# EDINBURG CISD

## ADDENDUM 2

CSP 22-70

### Edinburg High School Heating & Air Condition (HVAC) Improvements Funded through the Elementary & Secondary Emergency Relief (ESSER) Funds April 6, 2022

**1 ENLARGED MECHANICAL ROOM - A110**  
M3.01 1/4" = 1'-0"

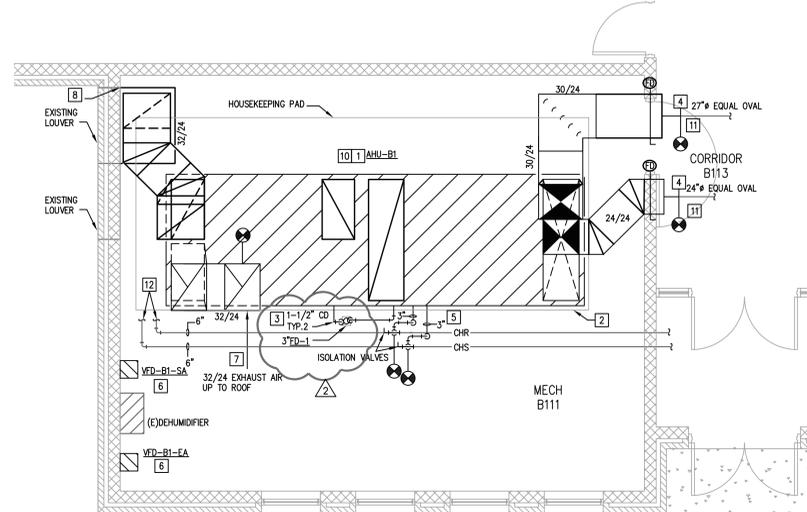
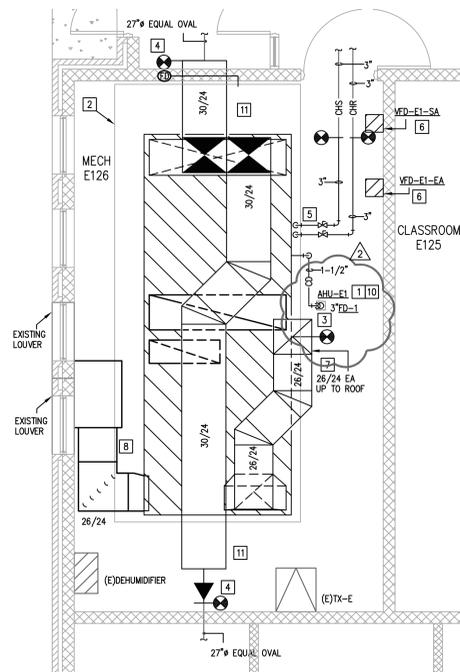
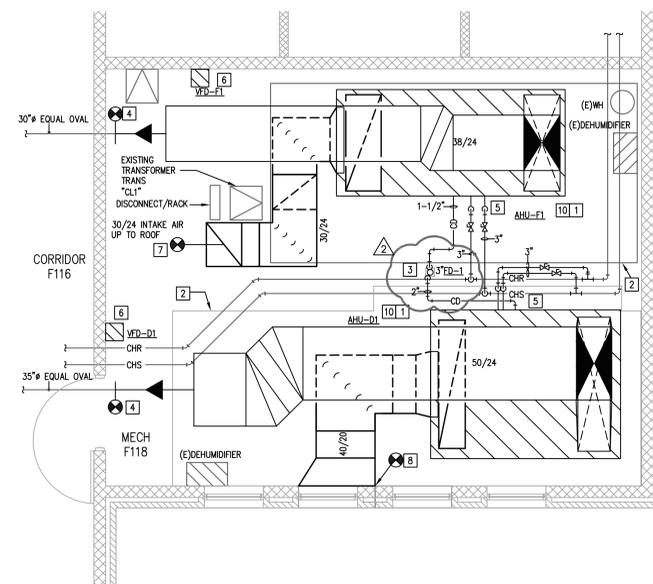
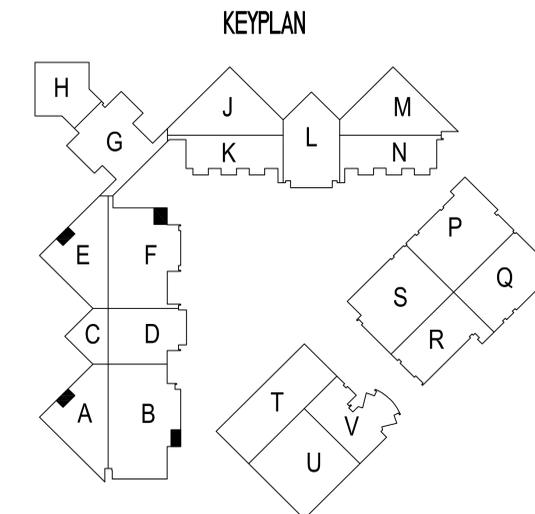
- A. Revised keyed notes 3, 9, 10.

**1**  
 M3.03 **ENLARGED MECHANICAL ROOM - MEZZANINE AREA P**  
 1/4" = 1'-0"

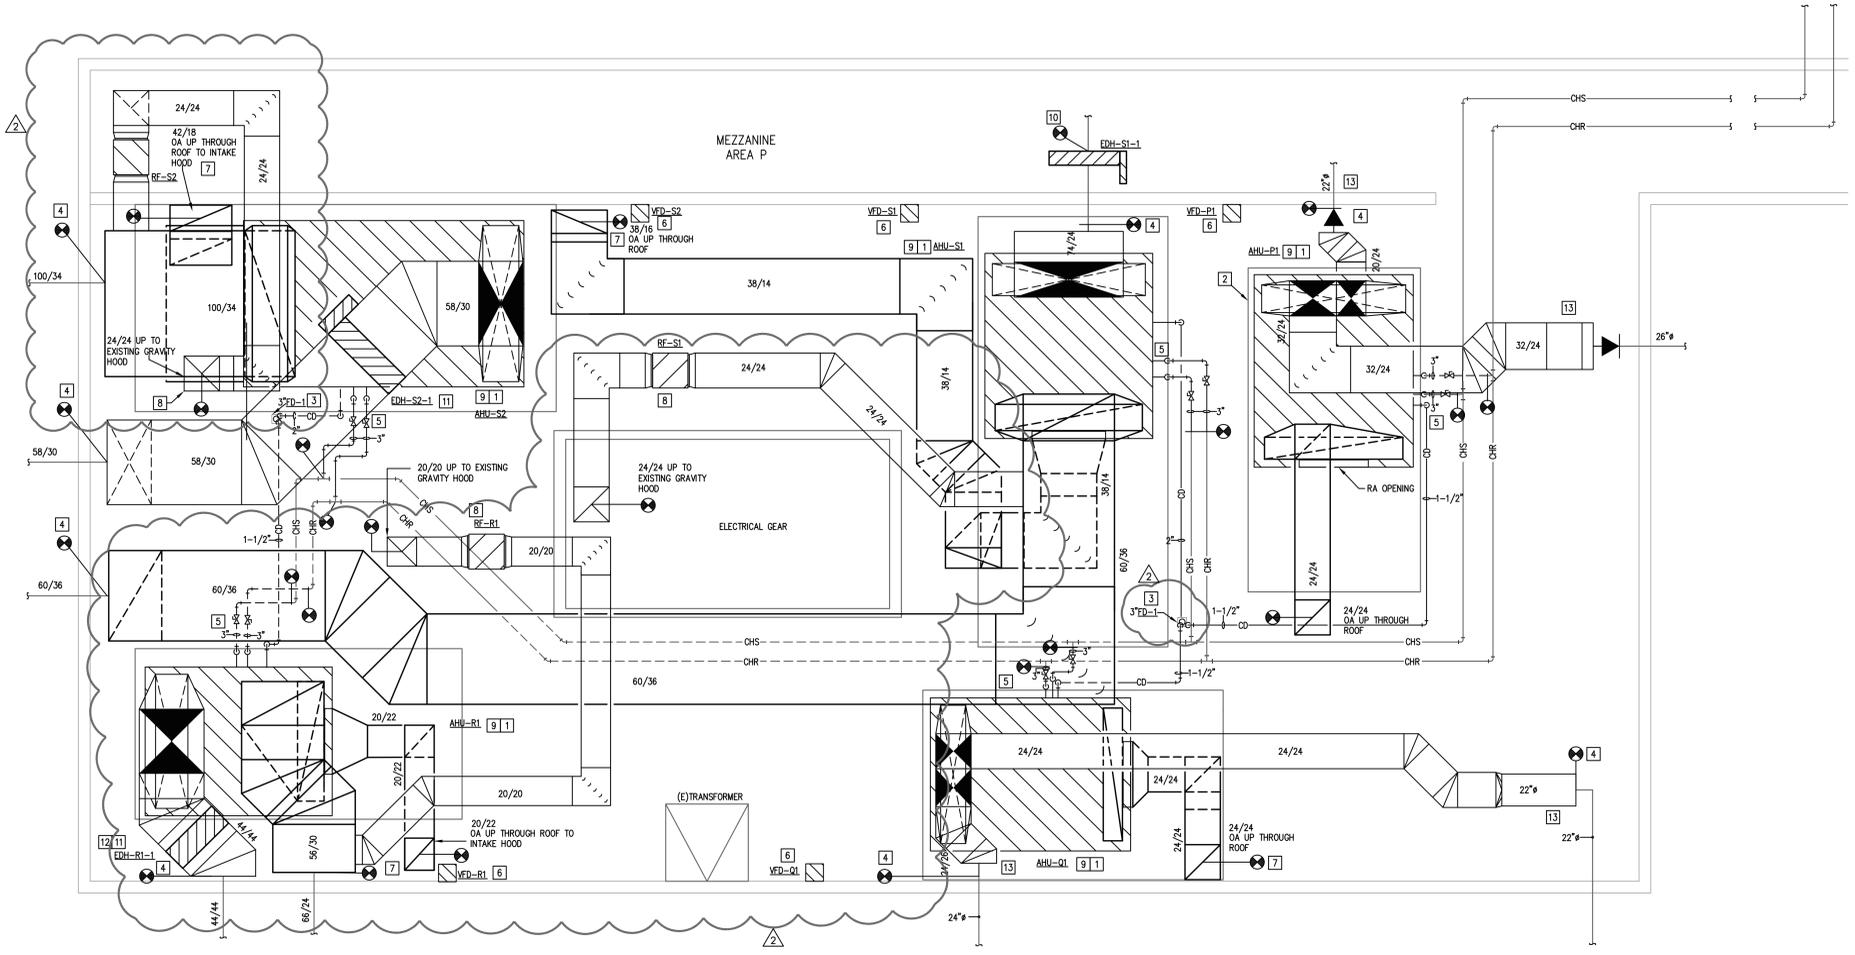
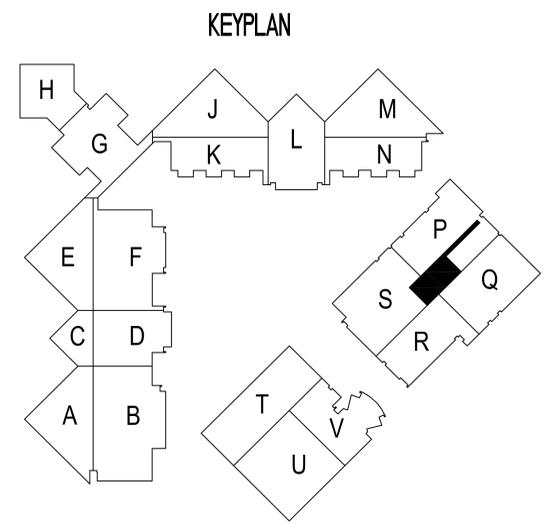
- A. Indicate new relief fans.
- B. Revised keyed notes 3, 8, 9.

**1** ENLARGED MECHANICAL ROOM - MEZZANINE AREA U  
 M3.04 1/4" = 1'-0"

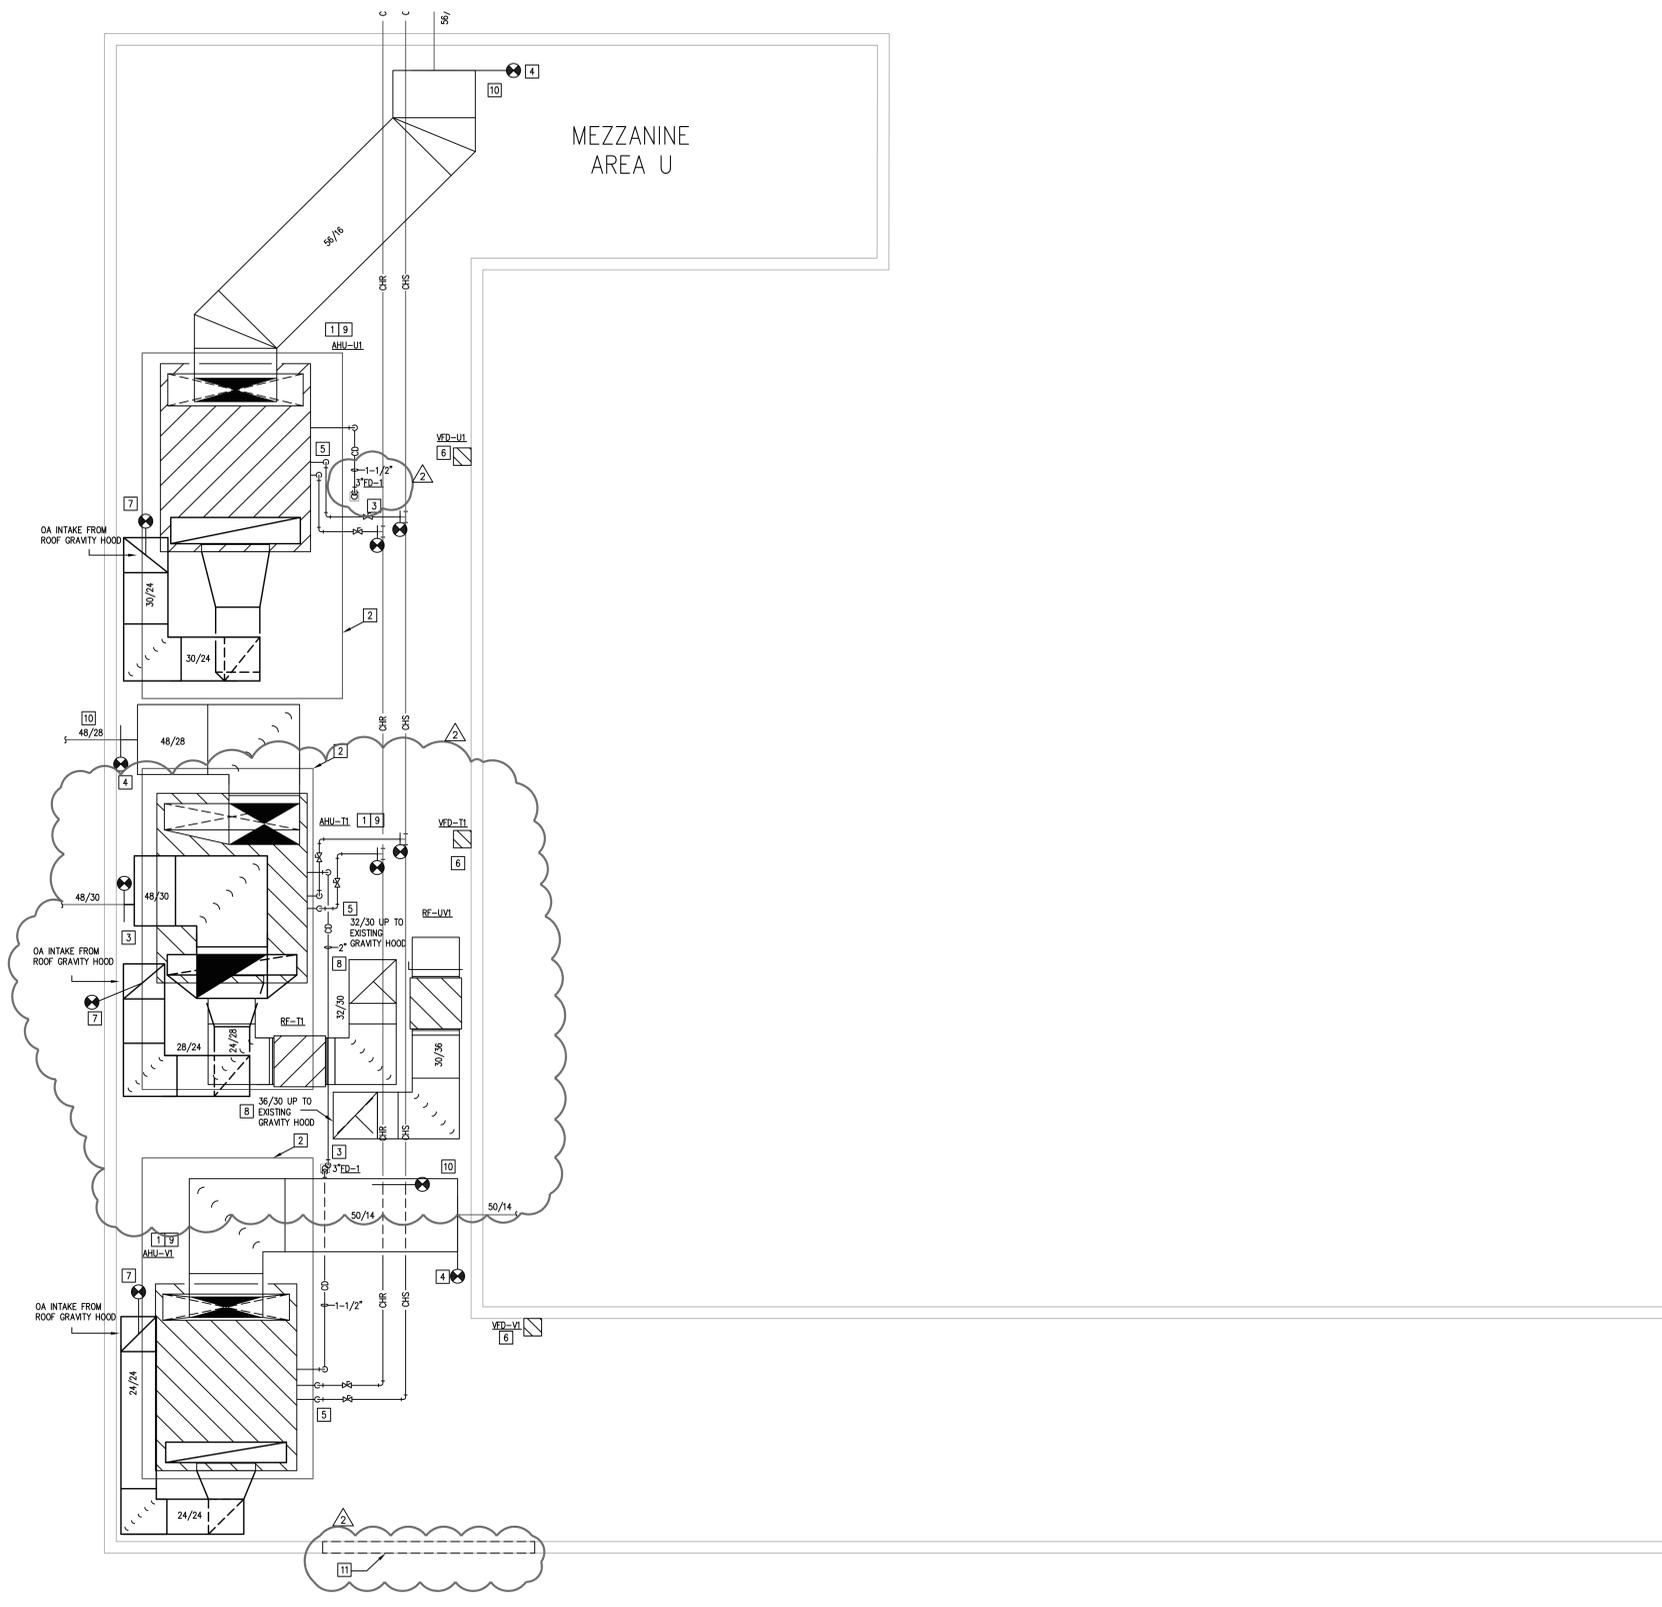
- B. Revised keyed notes 3, 8, 9.
- C. Added keyed note 11.

**1** ENLARGED MECHANICAL PLAN - MEZZANINE KITCHEN  
 M3.05 1/4" = 1'-0"

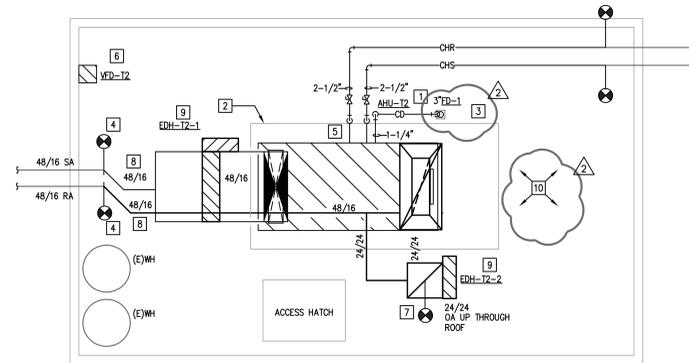
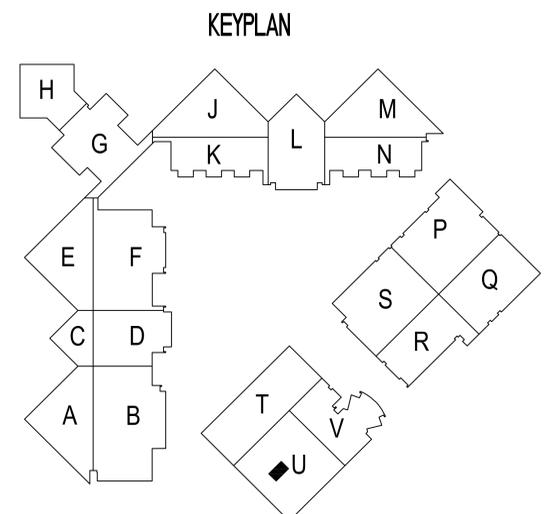
- A. Indicate new relief fans. Refer to M5.02 for schedules.
- B. Revised keyed notes 3, 8.
- C. Added keyed note 10.

**1** ENLARGED MECHANICAL PLAN - MECHANICAL P143  
 M3.06 1/4" = 1'-0"

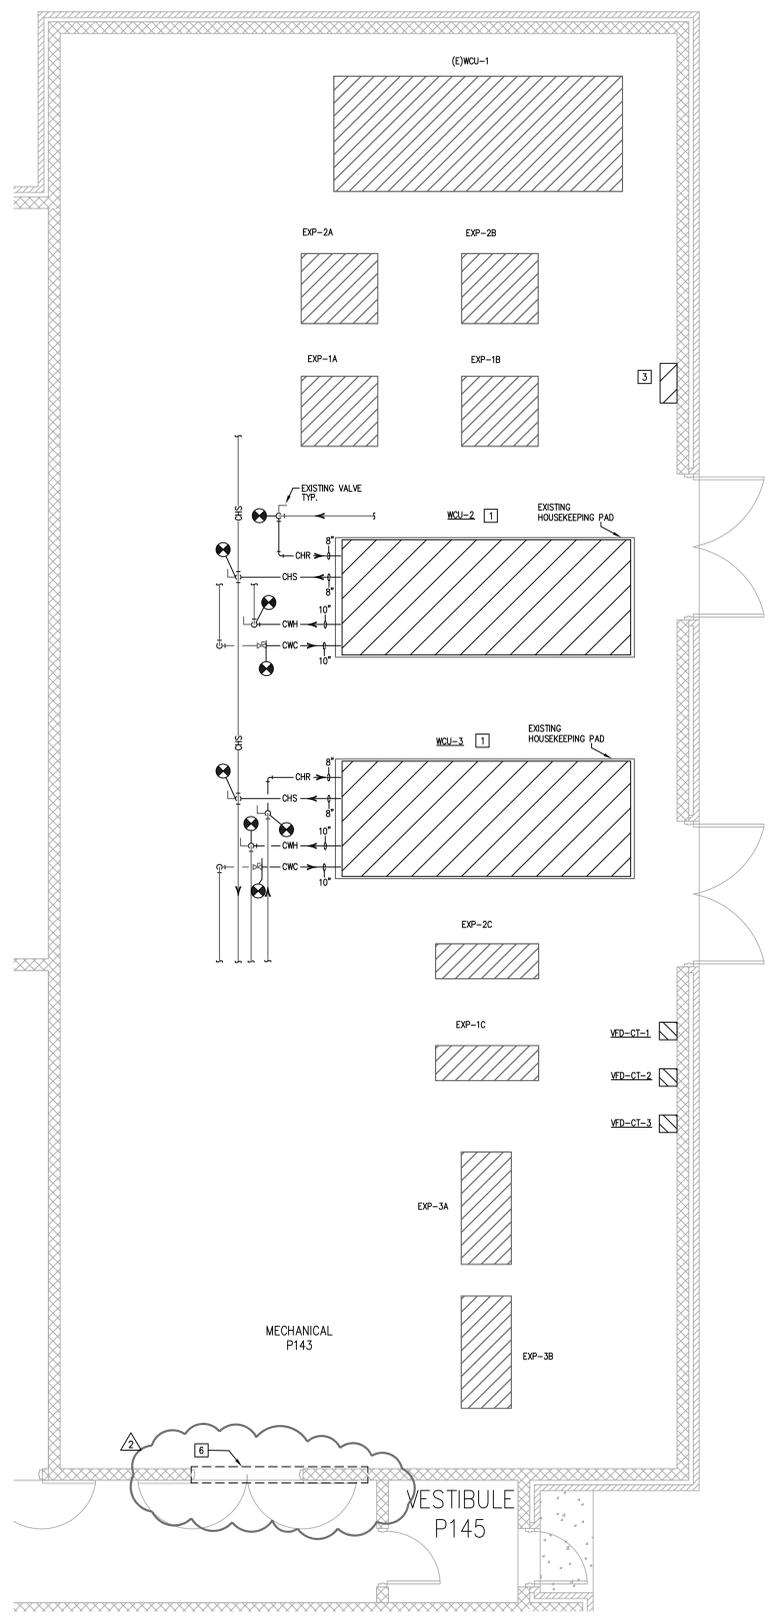
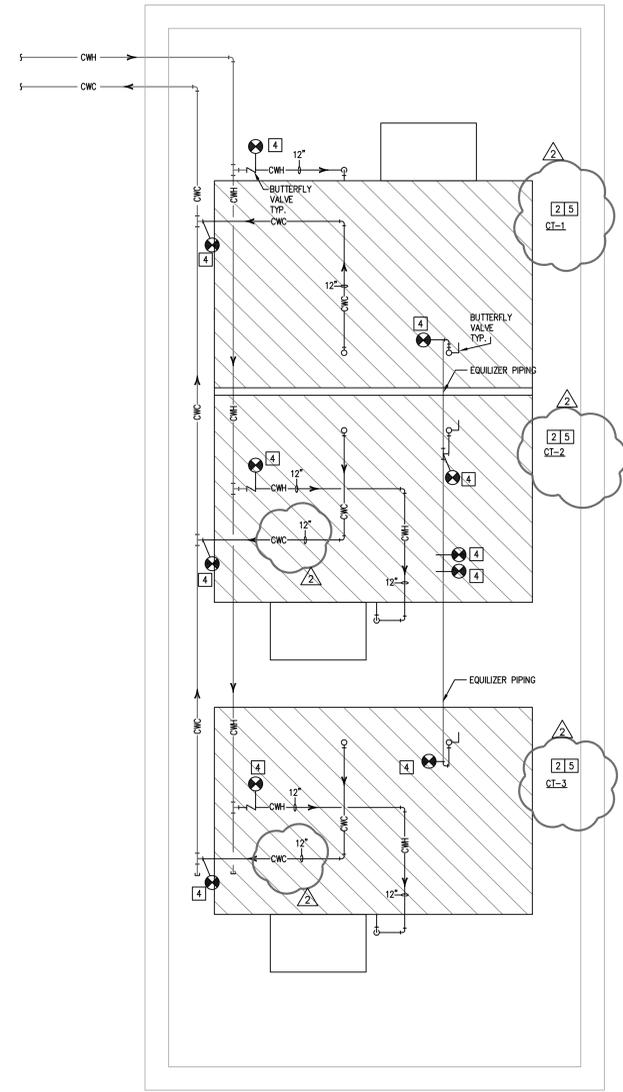
- A. Revised keyed note 2.
- B. Added keyed notes 5, 6.

MECHANICAL  
CONTROLS

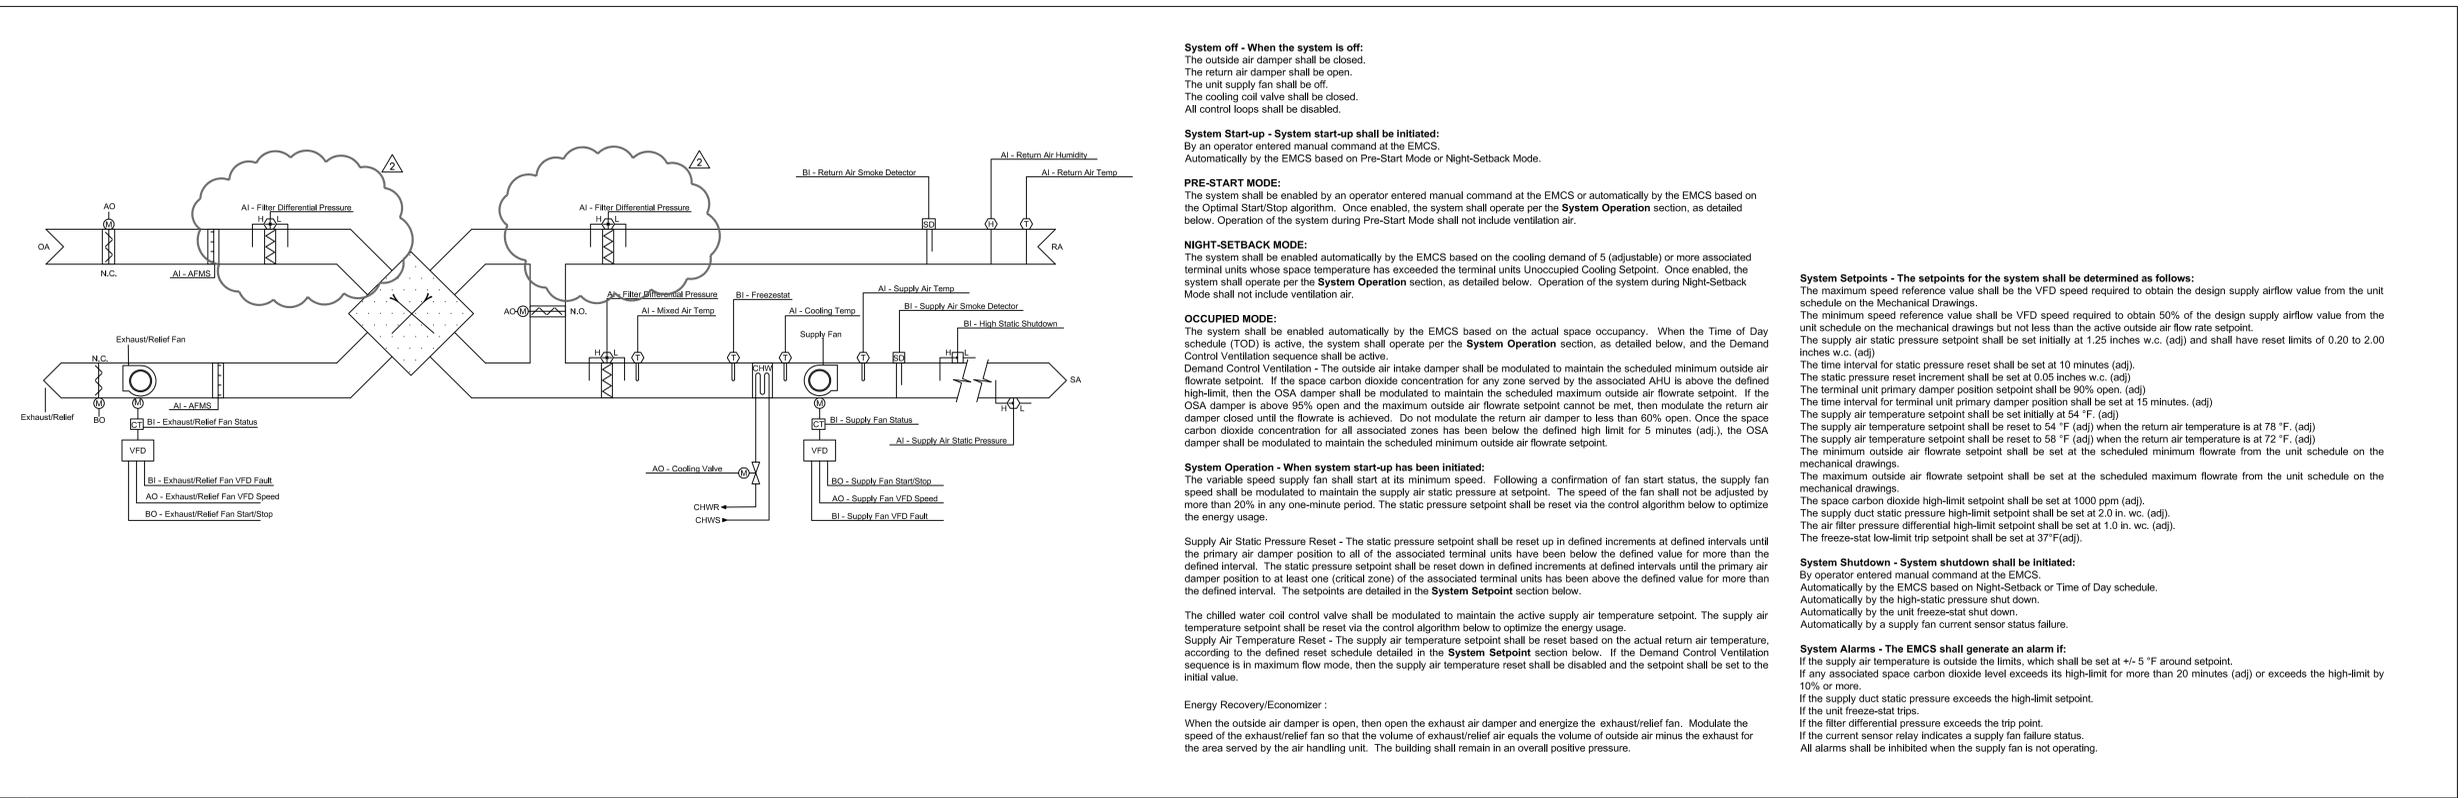
- A. Added controls diagram 4/M6.02 – Relief Fans – Building Pressure Control.
- B. Revised mechanical controls diagrams for M6.02, M6.03, M6.04, M6.05.
